PLAN OF PROPOSED IMPROVEMENT GRANDVIEW COMMONS

PHASE 20

ARIES WAY, GALILEO DRIVE, NORTH STAR DRIVE,
PLUTO STREET, O.L. 36 ALLEY, AND O.L. 38 ALLEY

CITY PROJECT NO. 53B2381
CONTRACT NO. 2381

REV 7-18-14 JMW	GRANDVIEW COMMONS PH. 20	SHEET NO.
REV 7-21-14 JMW	PROJECT NO. 53B2381	P-1
PLAN AND PROFILE		
ARIES WAY		CITY OF MADISON

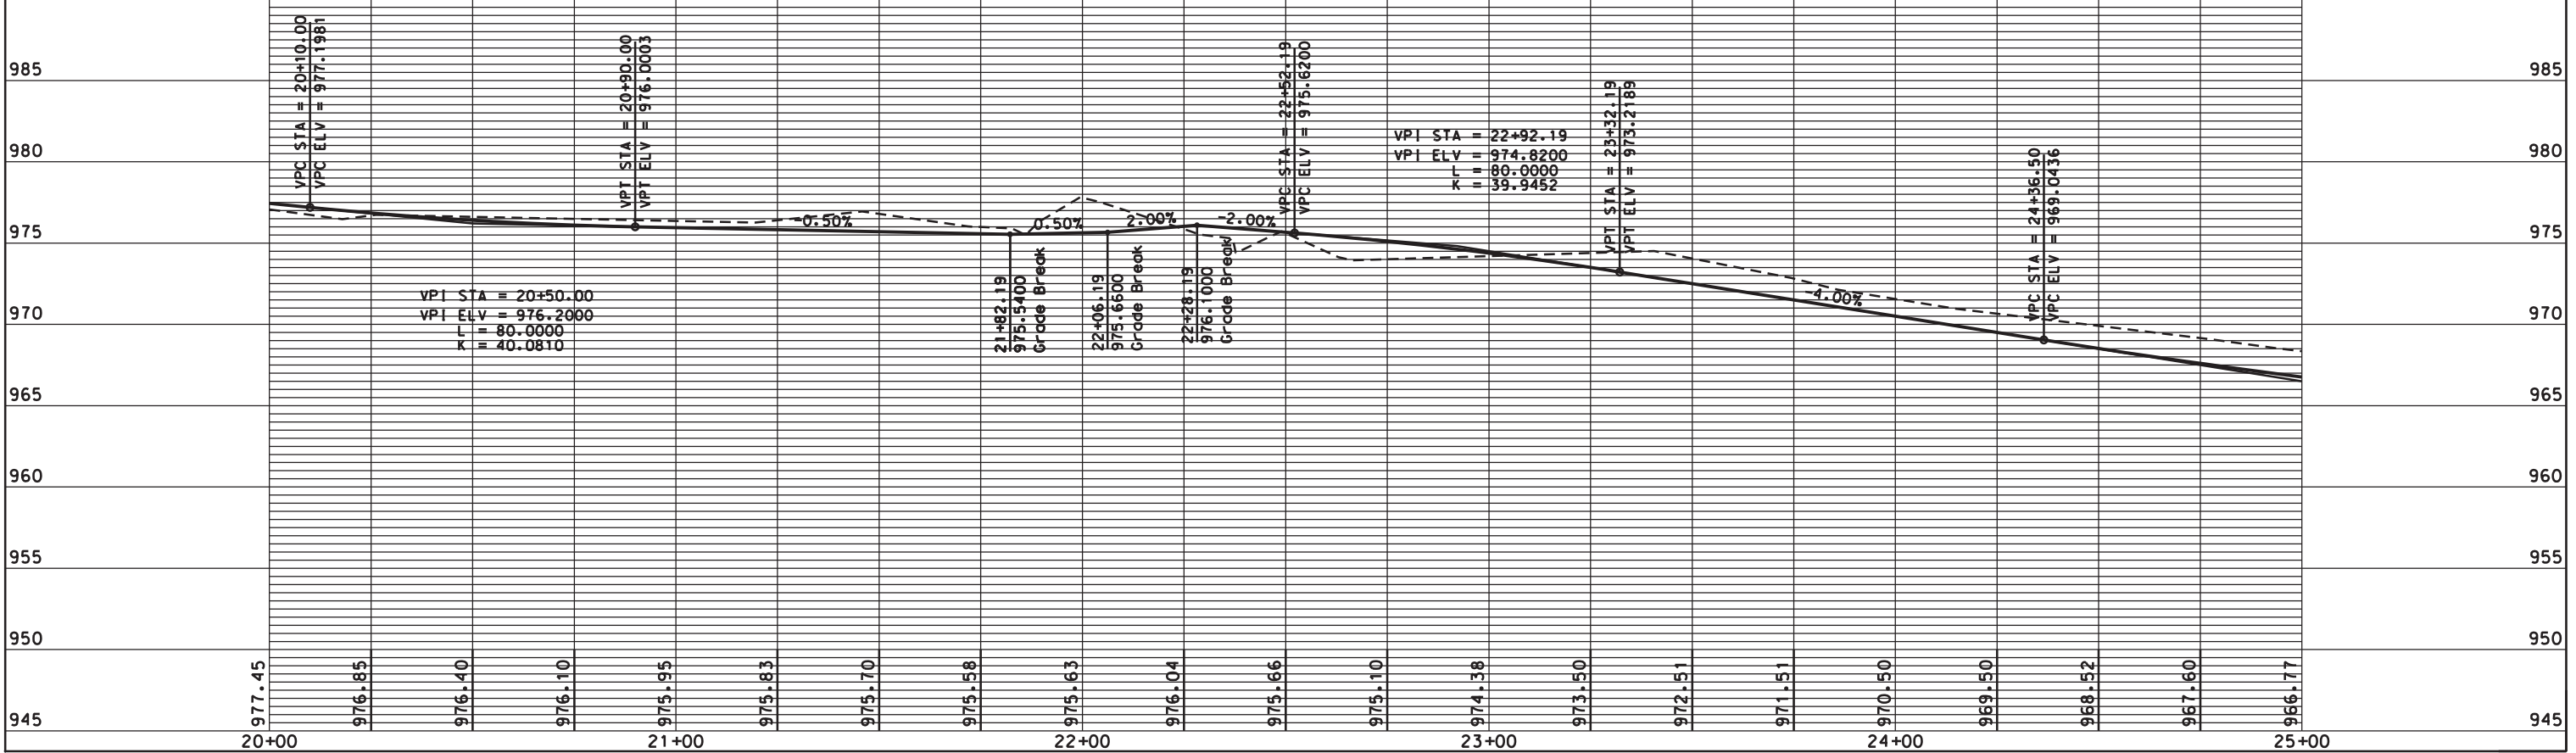
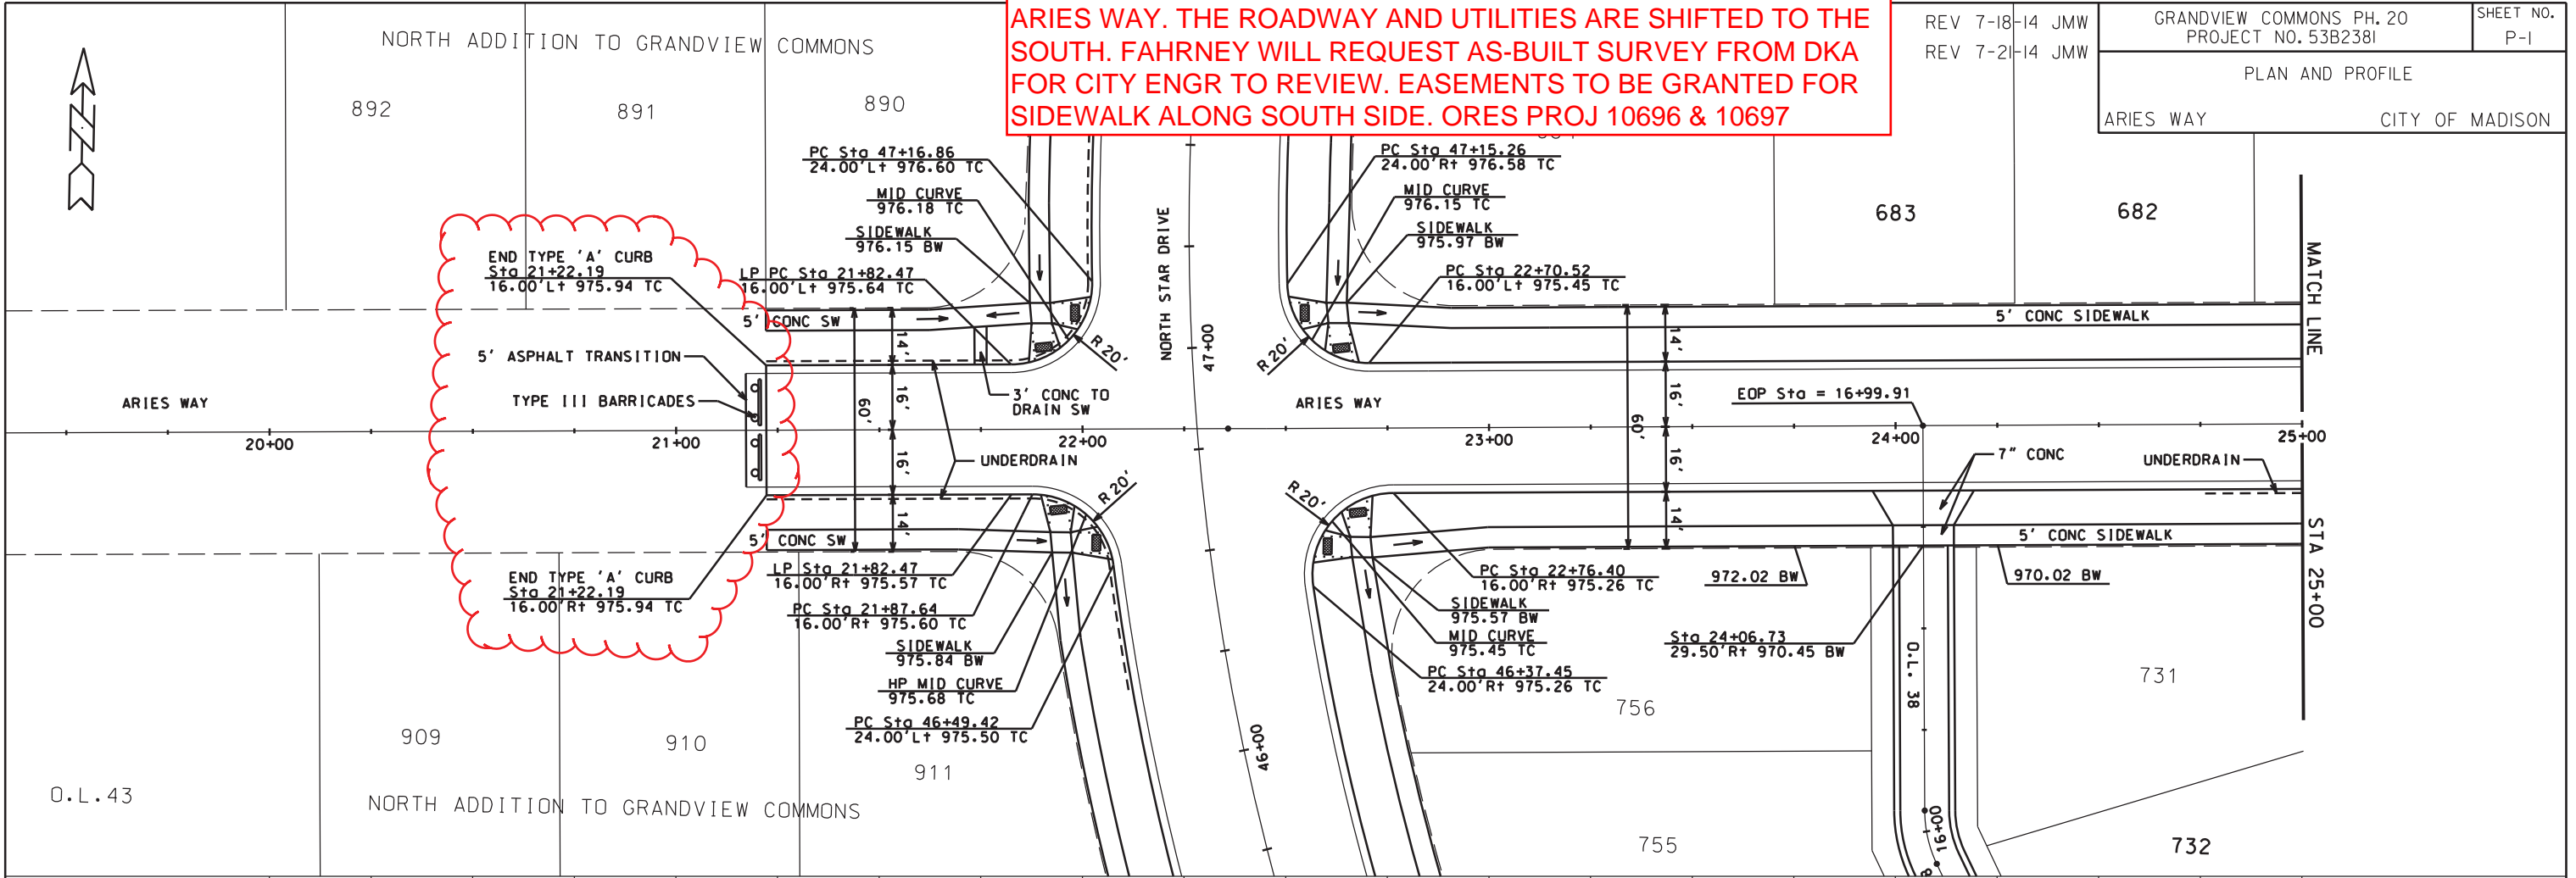
JOHN FAHRNEY/BRYAN/ MANNING/ERIC HOEL REPORT THAT DKA APPARENTLY ERRED IN STAKING OUT AND CONSTRUCTING ARIES WAY. THE ROADWAY AND UTILITIES ARE SHIFTED TO THE SOUTH. FAHRNEY WILL REQUEST AS-BUILT SURVEY FROM DKA FOR CITY ENGR TO REVIEW. EASEMENTS TO BE GRANTED FOR SIDEWALK ALONG SOUTH SIDE. ORES PROJ 10696 & 10697

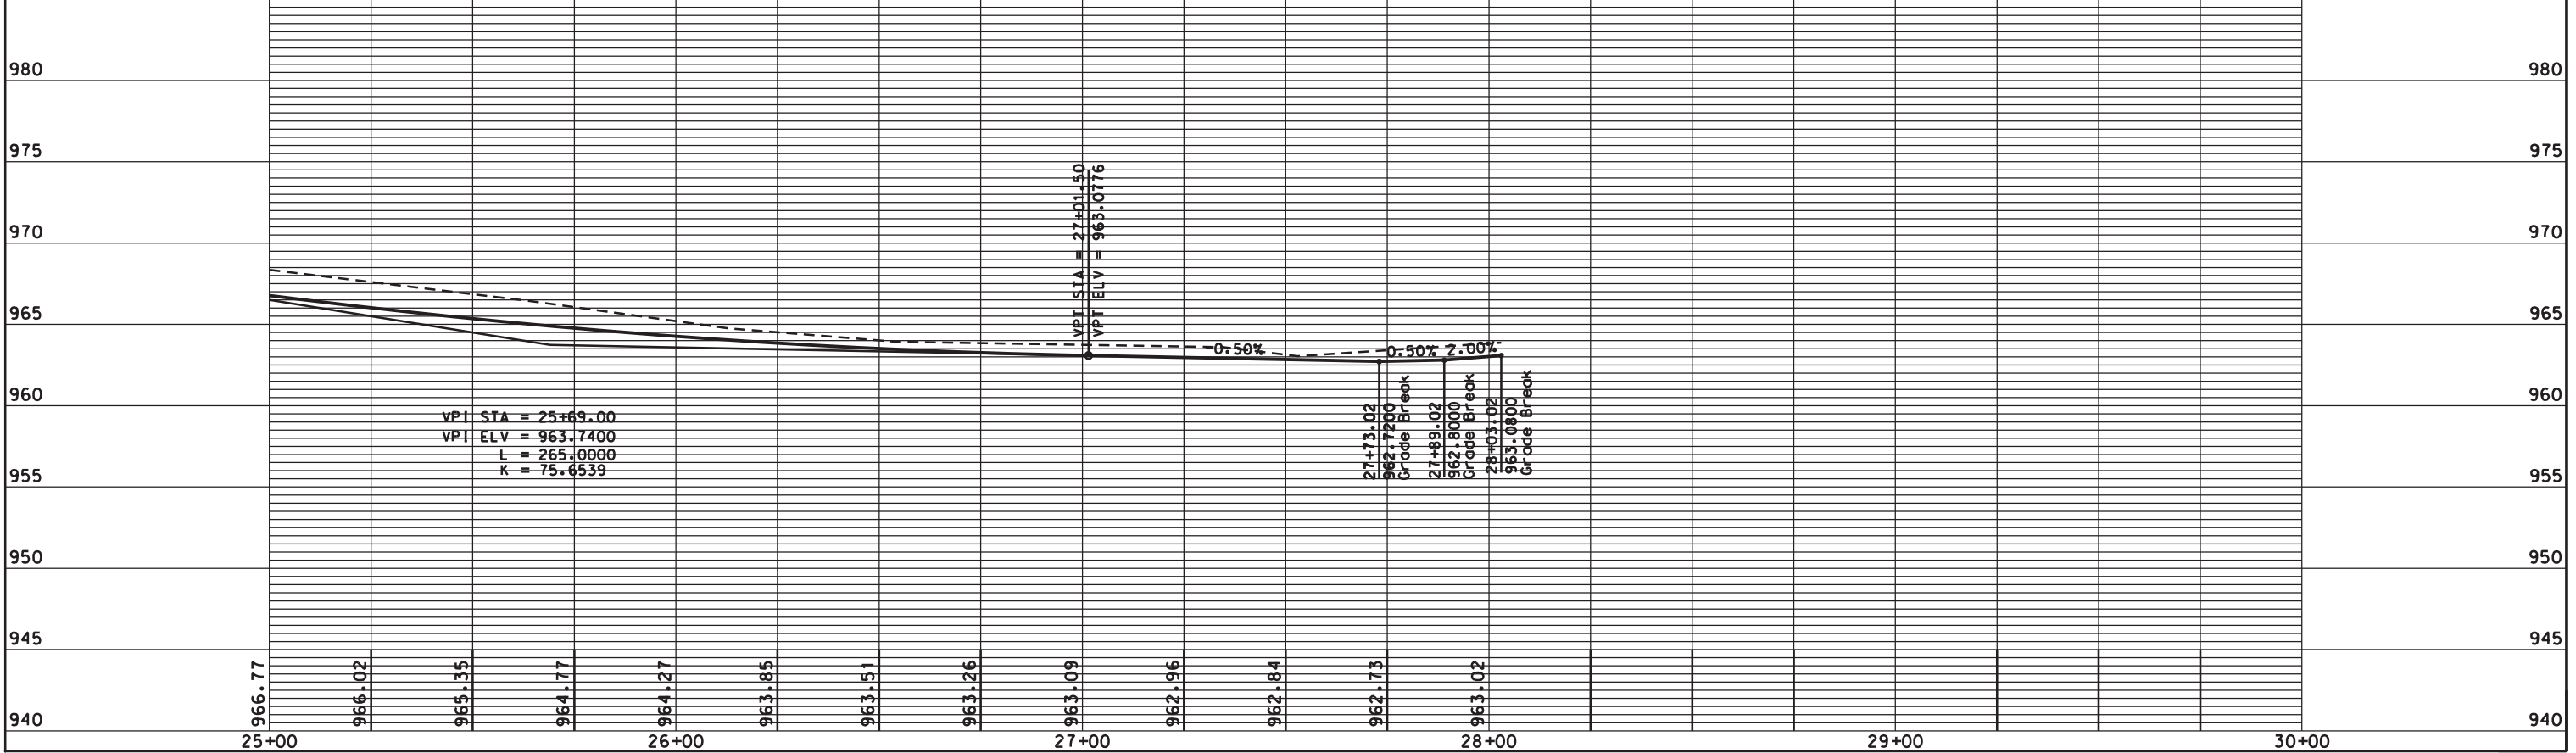
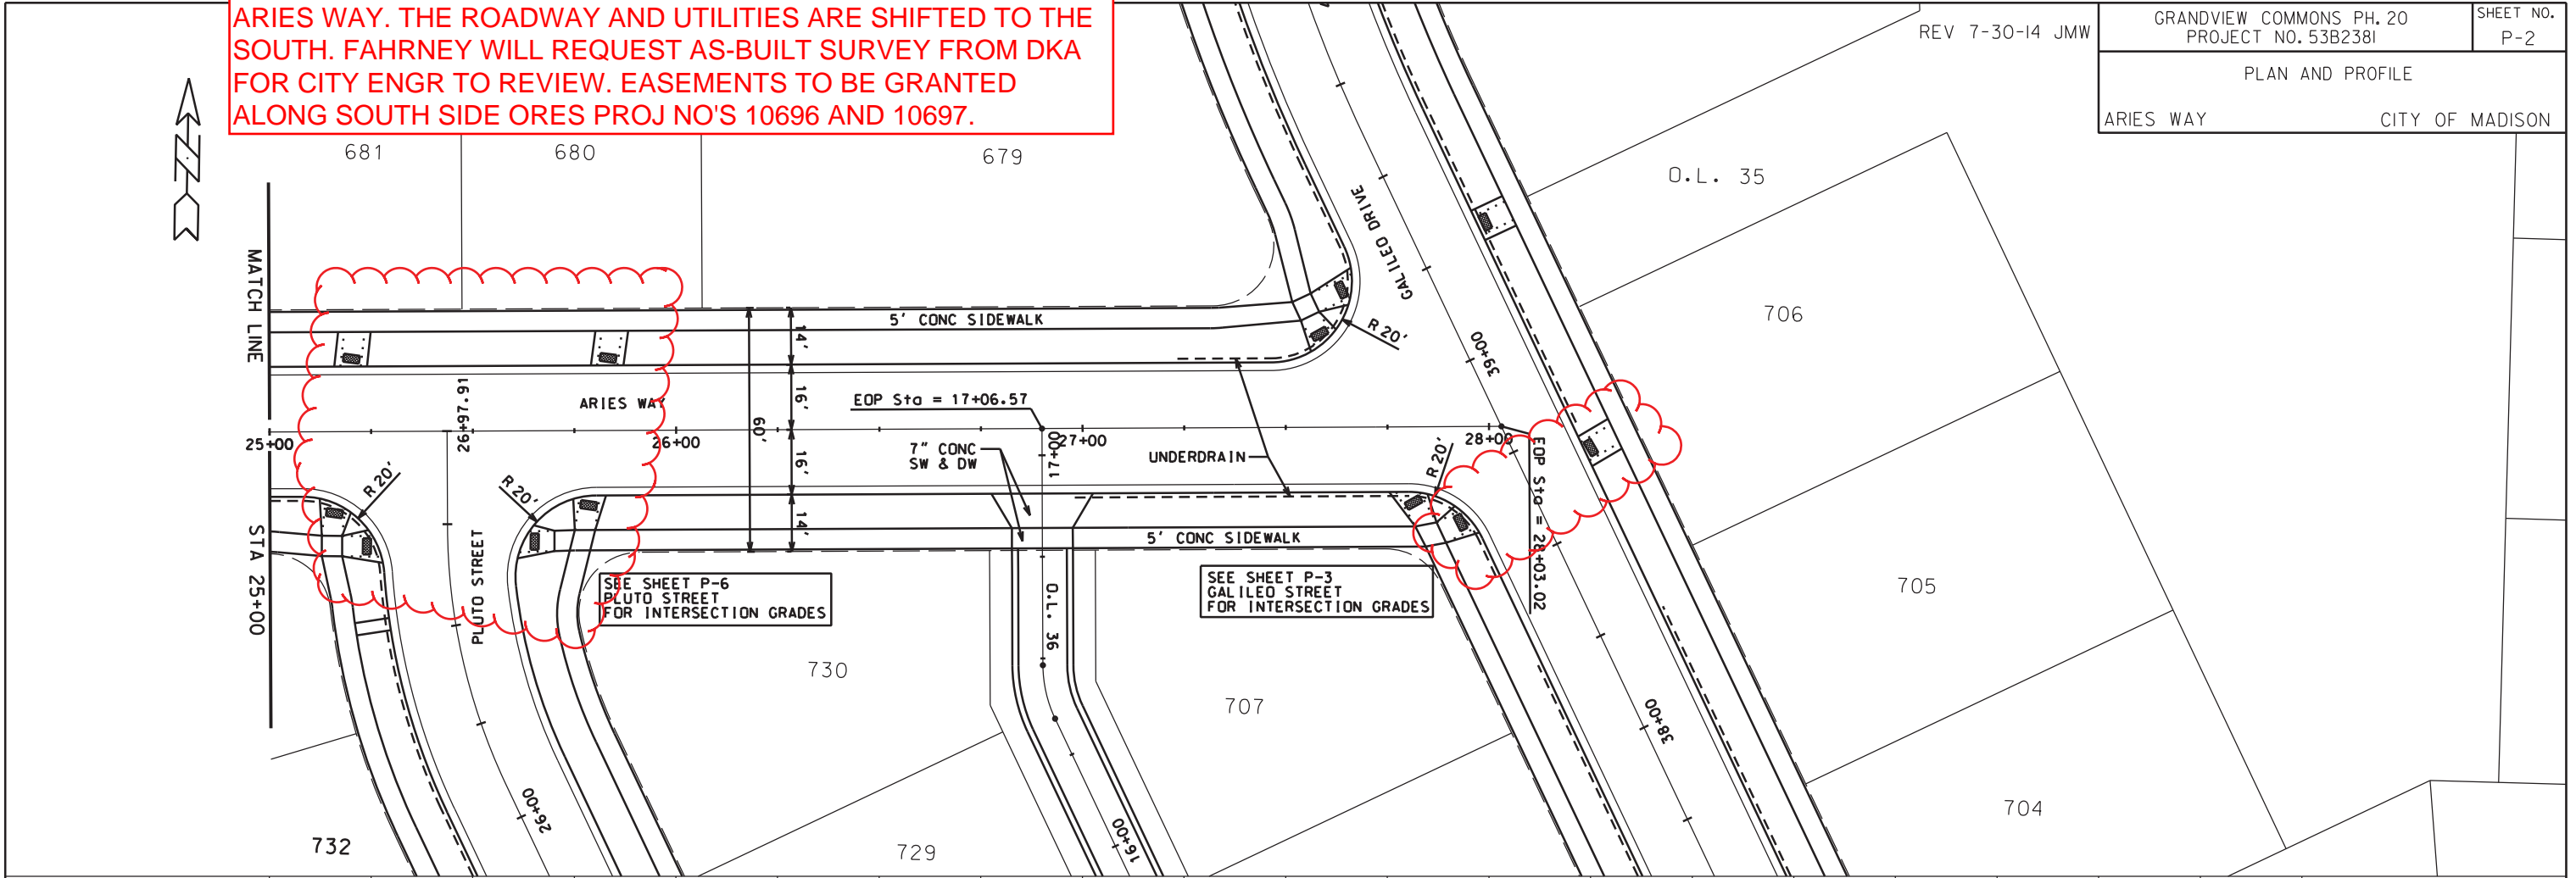
JOHN FAHRNEY/BRYAN/ MANNING/ERIC HOEL REPORT THAT DKA APPARENTLY ERRED IN STAKING OUT AND CONSTRUCTING ARIES WAY. THE ROADWAY AND UTILITIES ARE SHIFTED TO THE SOUTH. FAHRNEY WILL REQUEST AS-BUILT SURVEY FROM DKA FOR CITY ENGR TO REVIEW. EASEMENTS TO BE GRANTED ALONG SOUTH SIDE ORES PROJ NO'S 10696 AND 10697.
